Mel Bolling, c/o Jay Pence
Teton Basin District Ranger
P.O. Box 777
Driggs, ID83401
↑

COMMENTS ON THE GAND TARGHEE MASTER PLAN PROJECTS

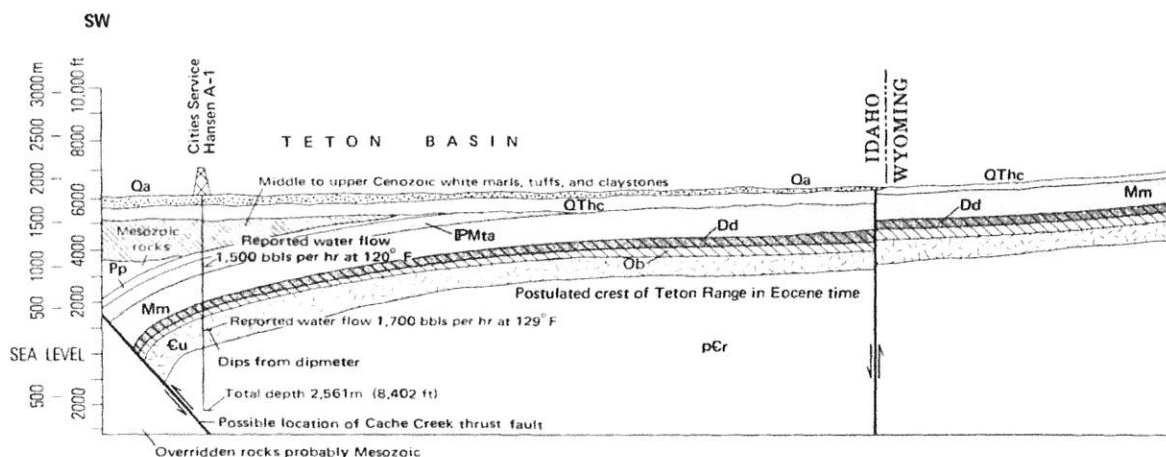
For many years it was above sea level, exposed to rain and it developed a karst terrain much like the present day Yucatan Peninsula. When the Amsden formation was deposited above it the many caves and sinkholes in the Madison were loosely refilled with weak brecciated limestone. This created pre-existing conduits for rapidly-moving ground water. These features are called paleokarst. A description of paleokarst in the Madison Formation can be found in Sando, 1988⁴ and a description of a re-excavated paleokarst in the Gros Ventre range can be found in: Keefer, 1963⁵.

The geology at Grand Targhee is a problem for the proposed expansion of the ski area. The Madison limestone is particularly permeable. Meteoric water falling on the Madison descends vertically to shale at the top of the Darby Formation and then runs down-dip to the west where it resurges at the Madison/Darby contact. The impermeable shale at the top of the Darby formation prevents the permeable limestone member in the middle of the Darby Formation (source of well water at Targhee) from being recharged from above and importantly, the Darby Formation only extends for a short distance up-dip to the east before it outcrops in cliffs, so it has a very limited recharge area.
